## Public Input No. 2426-NFPA 70-2023 [ Global Input ]

### Committee Statement

Figure 1

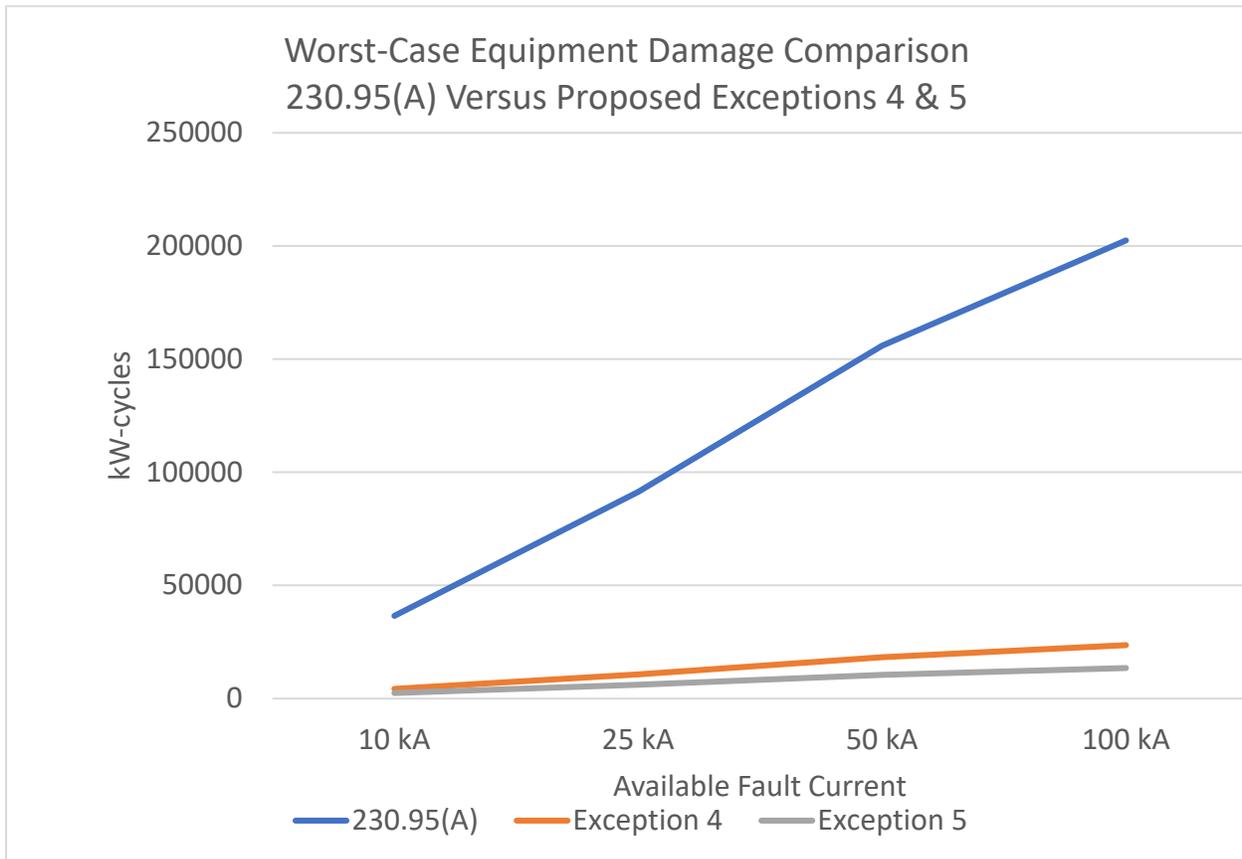
this proposed exception for circuit breakers (13,500 kW-Cycles) is less than 7% of the worst-case damage allowed by 230.95(A) (202,500 kW-cycles). See Figure 1

Figure 1 shows that equipment damage allowed by this Public Input is always, from 10,000 amperes available through 100,000 amperes available, just a small fraction of the equipment damage allowed by 230.95(A).

**Conclusion:** This Public Input takes advantage of the arc-energy reduction requirements found in 240.67 and 240.87. It provides an exception for GFPE requirements whenever specific 240.67 and 240.87 methods to reduce clearing time are utilized. Arc energy reduction methods, as detailed in Exceptions 4 and 5, must open for **“all”** actual arcing ground faults and in a much faster time than allowed by 230.95(A). Reviewing Figure 1, it becomes obvious that Exceptions 4 and 5 will limit the arcing fault damage to the equipment to a level that is considerably less than that currently allowed by the requirements found in 230.95(A).

**Figure Informational Note Figure 230.1 Services.**

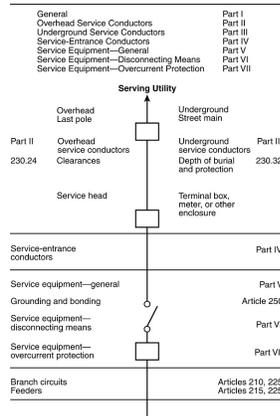
The substance of Figure 230.1 reflects agreement on "service point" identified in the IEEE 2023 NESC and should be explicitly referenced here.

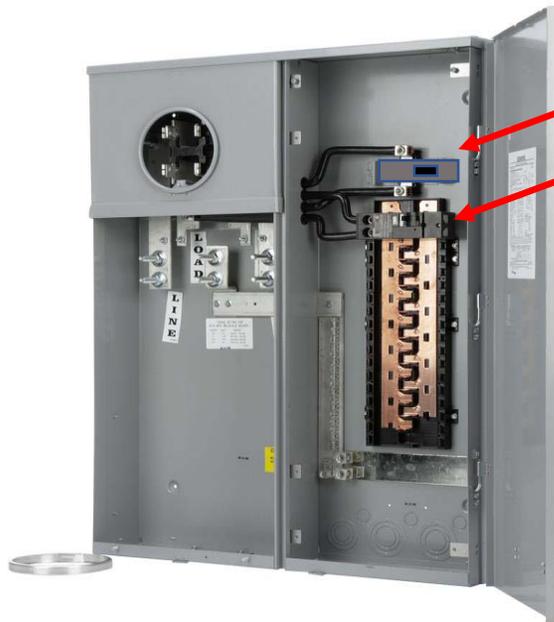
would not necessarily change the number of field terminations. Additionally, no substantiation is provided on potential failures of field terminations.

**Resolution:** UL 67, Standard for Panelboards, covering these devices has been updated to require that each service disconnect be installed in a separate compartment per the 230.71(B) requirement. The requirement to install the additional service disconnects in separate compartments or enclosures

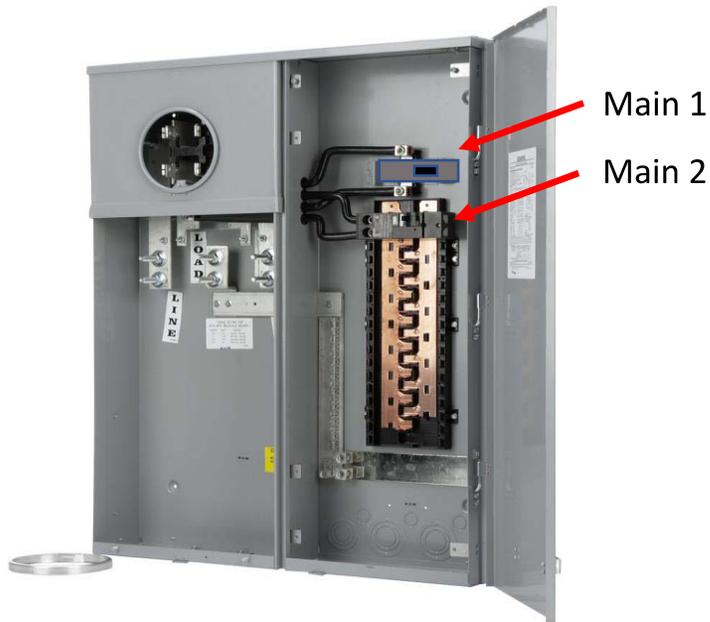
Many utilities do not permit a single main disconnect ahead of unmetered conductors as 230.71B (2) permits.

Utility Line side terminations and metering compartments are in separate barriered sections not accessible in the Service Disconnect sections.

Figure 1

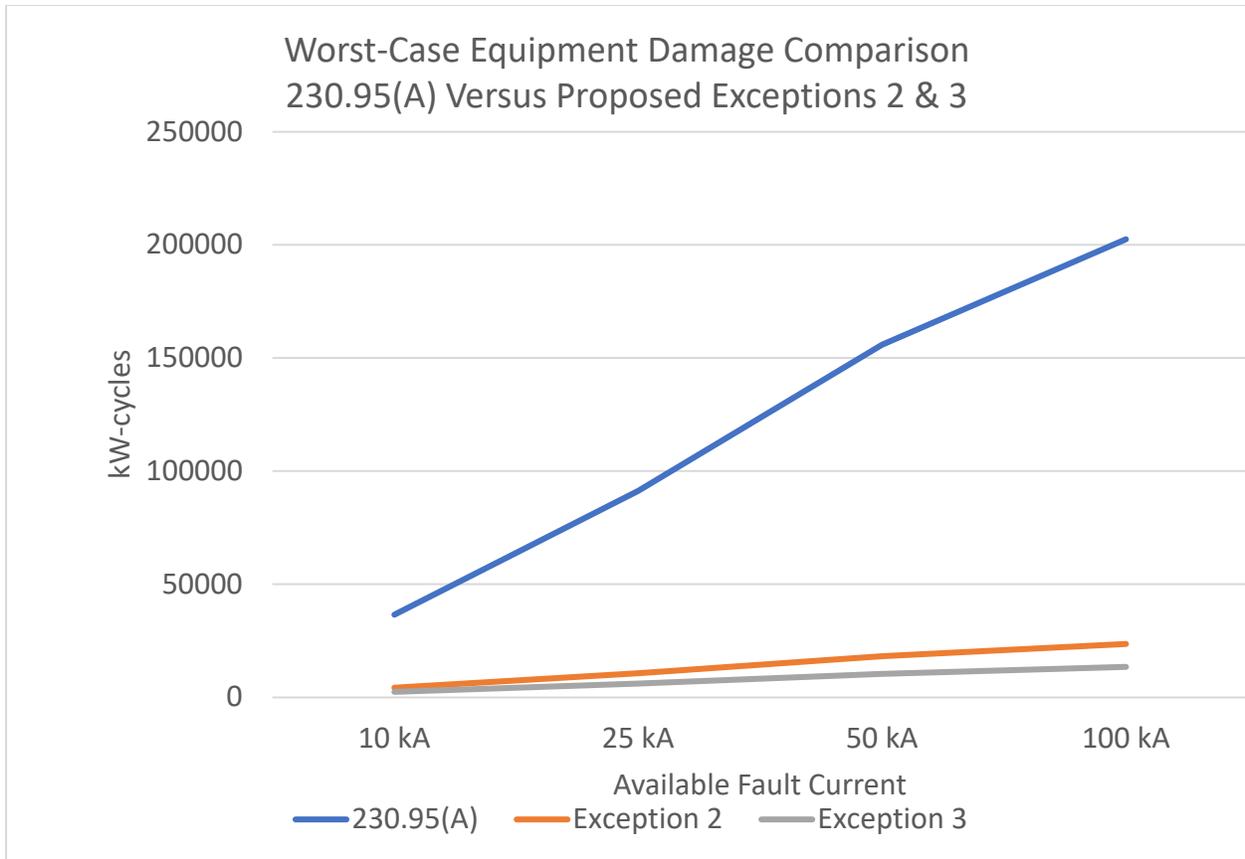
**As allowed by Proposed Exception No. 3.** For an available fault current of 100kA, the IEEE 1584-2018 minimum arcing current is 33.75 kA. Assuming an opening time of 4 cycles for 240.87(B)(1), (B)(2), or (B)(4), the equipment damage is (33.75 kA X 4.0 cycles X 100 arcing volts) = 13,500 kW-cycles. Assuming an opening time of 3 cycles for 240.87(B)(5) or (B)(6), the equipment damage is (33.75 kA X 3 cycles X 100 arcing volts) = 10,125 kW-cycles. Worst-case damage for the minimum arcing current with this proposed exception for circuit breakers (13,500 KW-Cycles) is less than 7% of the worst-case damage allowed by 230.95(A) (202,500 kW-cycles). See Figure 1

Figure 1 shows that equipment damage allowed by this Public Input is always, from 10,000 amperes available through 100,000 amperes available, just a small fraction of the equipment damage allowed by 230.95(A).

**Conclusion:** This Public Input takes advantage of the arc-energy reduction requirements found in 240.67 and 240.87. It provides an exception for GFPE requirements whenever specific 240.67 and 240.87 methods to reduce clearing time are utilized. Arc energy reduction methods, as detailed in Exceptions 2 and 3, must open for **“all”** actual arcing ground faults and in a much faster time than allowed by 230.95(A). Reviewing Figure 1, it becomes obvious that Exceptions 2 and 3 will limit the arcing fault damage to the equipment to a level that is considerably less than that currently allowed by the requirements found in 230.95(A).

Figure 1

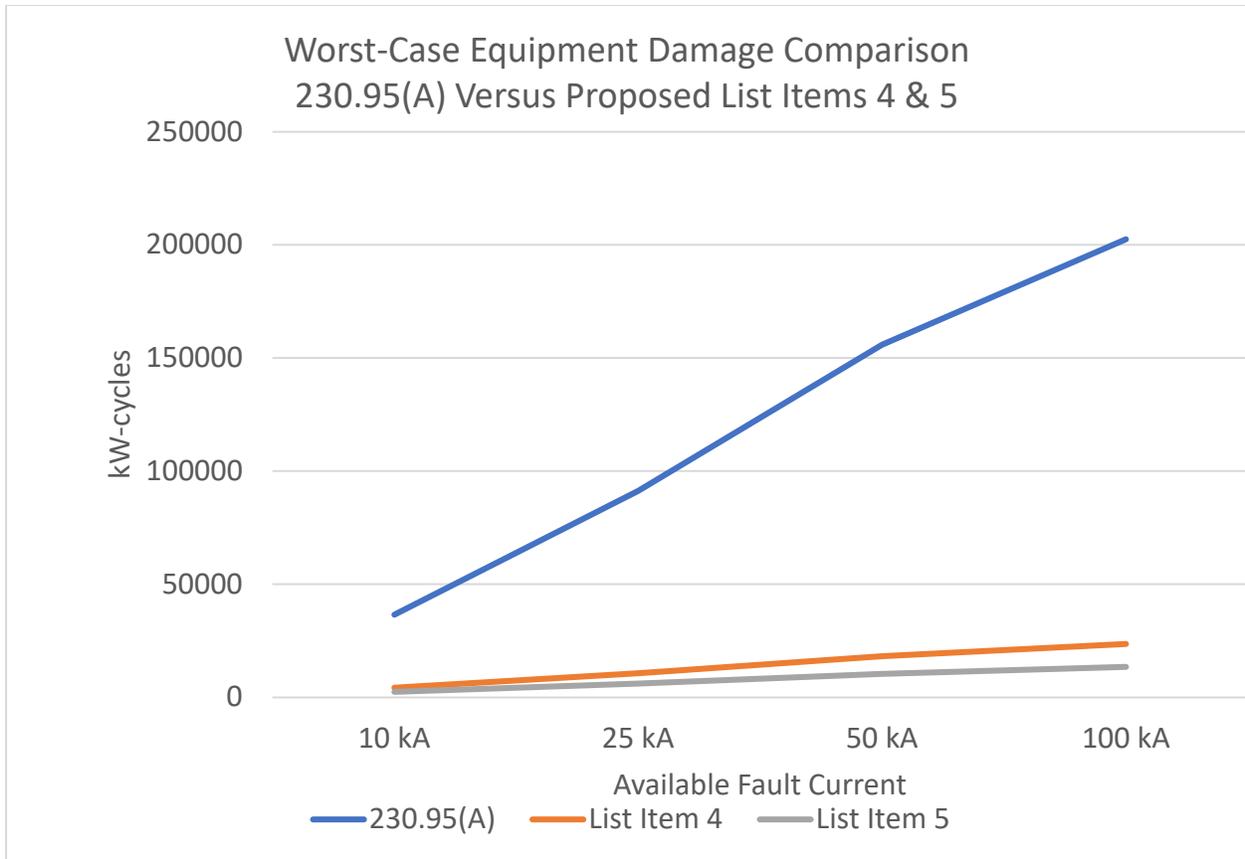
**As allowed by 230.95(A).** For an available fault current of 100kA, the IEEE 1584-2018 three phase minimum arcing current is 33.75 kA. Using the maximum 230.95(A) opening time of 60 cycles, the equipment damage is (33.75 kA X 60 cycles X 100 arcing volts) = 202,500 kW-cycles. See Figure 1.

Figure 1 shows that equipment damage allowed by this Public Input is always, from 10,000 amperes available through 100,000 amperes available, just a small fraction of the equipment damage allowed by 230.95(A).

**Conclusion:** This Public Input takes advantage of the arc-energy reduction requirements found in 240.67 and 240.87. It doesn't require GFPE whenever specific 240.67 and 240.87 methods to reduce clearing time are utilized. Arc energy reduction methods, as detailed in List Items 4 and 5, must open for "all" actual arcing ground faults and in a much faster time than allowed by 230.95(A). Reviewing Figure 1, it becomes obvious that List Items 4 and 5 will limit the arcing fault damage to the equipment to a level that is considerably less than that currently allowed by the requirements found in 230.95(A).
